CANADIAN NIAGARA POWER INC.

**Re: Canadian Niagara Power Inc. ("CNPI") – 2022 Cost of Service Application  
Interrogatory Responses  
(EB-2021-0011)**

Reference: Exhibit 3, page 17

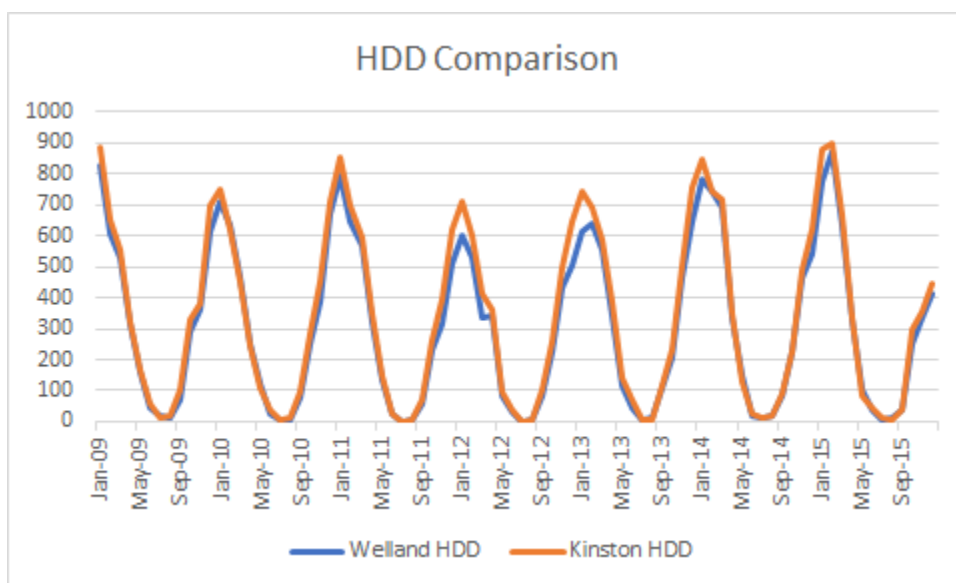
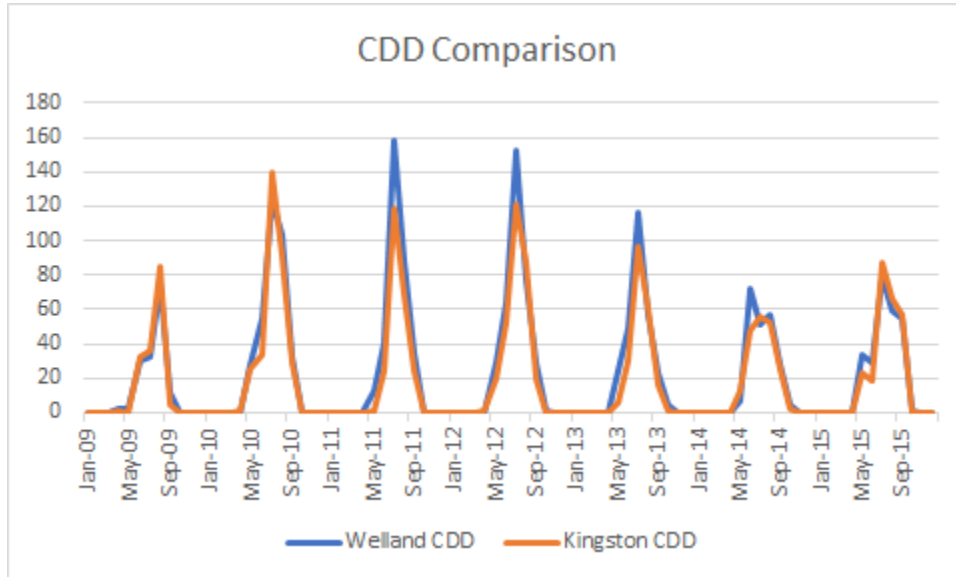
- a) It is noted that CNPI has two distinct service areas that are separated by a substantial distance (Exhibit 1, page 22). The Application (page 17) states that the regression model uses “the monthly HDD and CDD as reported by Environment Canada for the Welland-Pelham weather station”. Has CNPI analyzed how the CDD and HDD values from the Welland-Pelham weather station compare with the HDD and CDD values reported from weather stations in the proximity of its Gananoque service area?
- i. If yes, are the values materially different and, if so, why weren't these differences factored into the load forecast methodology?
